DEPARTMENT OF THE NAVY
SOUTHWEST DIVISION
NAVAL FACILITIES ENGINEERING COMMAND
ENVIRONMENTAL DIVISION
1220 PACIFIC HIGHWAY, RM 18
SAN DIEGO, CALIFORNIA 92132-5181

M60050.000935
MCAS EL TORO
SSIC # 5090.3

5090
Ser 09E/641
April 27, 1995

Total Dissolved Solids (TDS) Increase Impacts to Water Usage

FIGURE
SIMULATED GROUNDWATER
PATHLINES FROM TCE
PLUME IN PRINCIPAL
AQUIFER AFTER 20 YEARS
ALTERNATIVE 1
MCAS EL TORO
GROUNDWATER MODELING REPORT

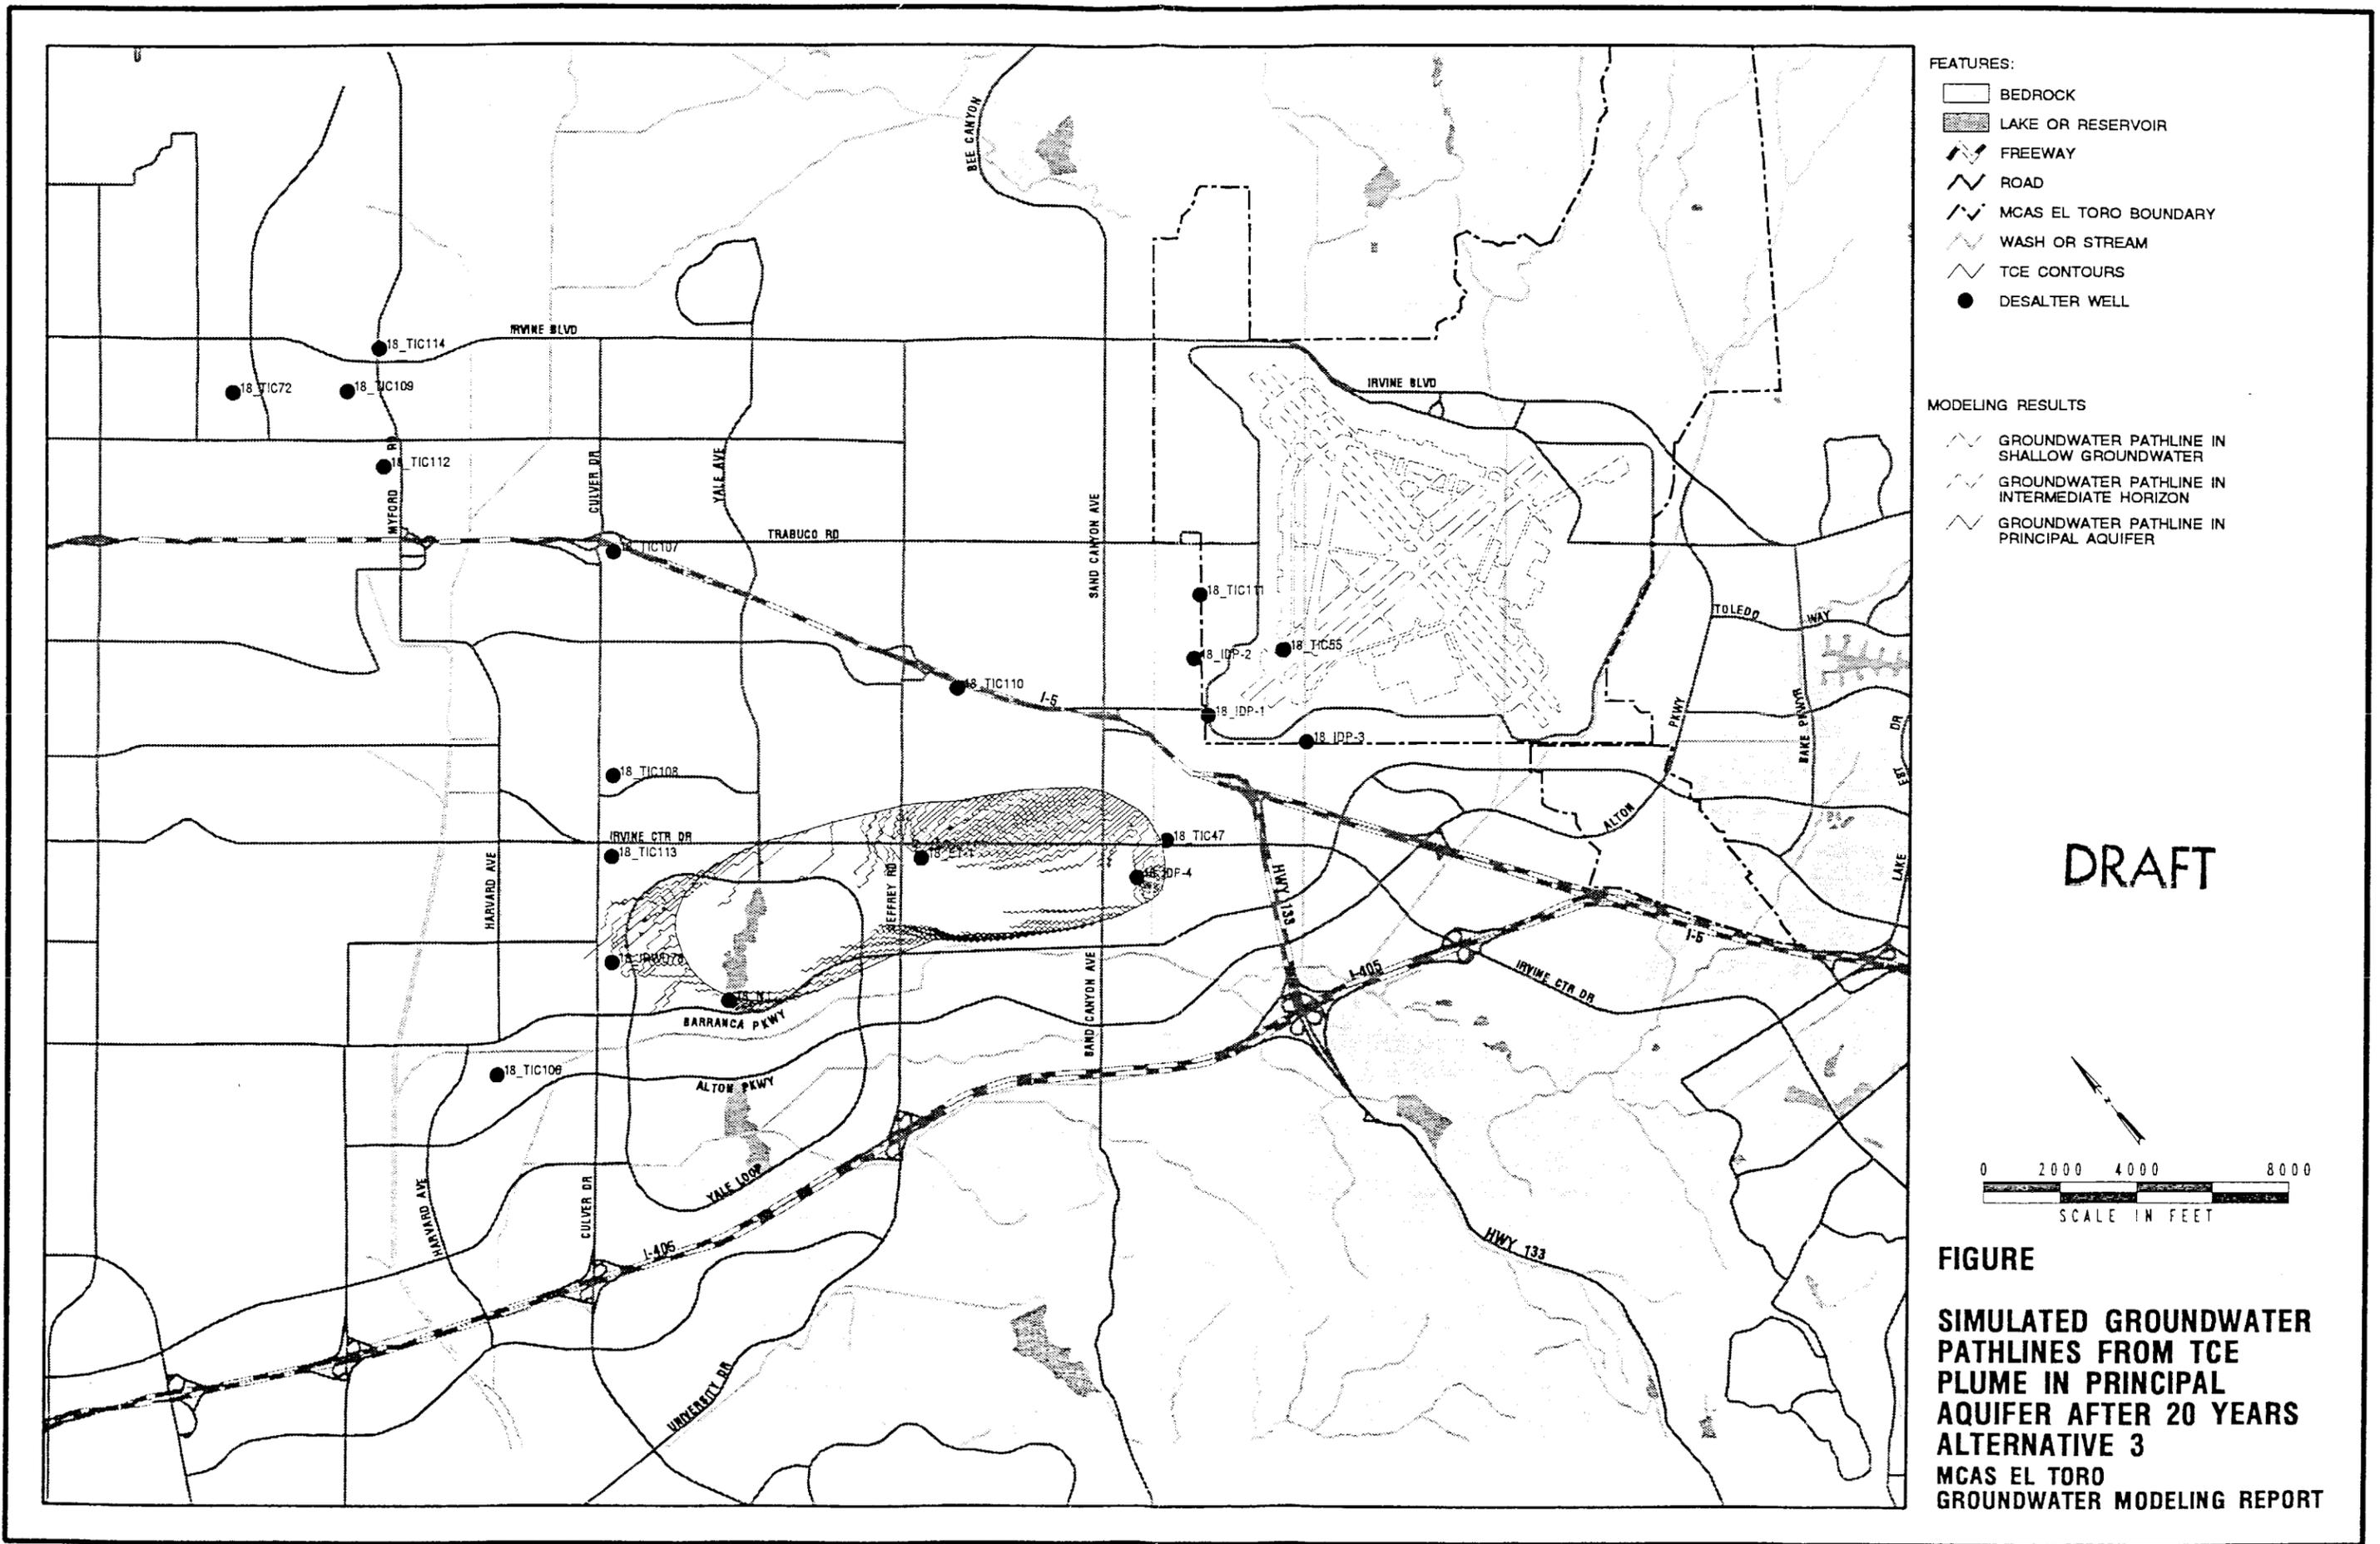
At the April 13 meeting, 20 year simulated TCE plume groundwater pathlines for the shallow groundwater (enclosure 1) and principal aquifer (enclosure 2) were presented. Both sets of figures model Alternative #1 (No Action), Alternative #2 (Independent DON stand-alone system), and Alternative #3 (Irvine Desalter Project). Although the simulations are for TCE particle tracking, TDS particle tracking would be similar. Even though both Alternative #2 and #3 are improvements over the No-Action scenario, the modeling clearly indicates that Alternative #2 controls particle migration much better than
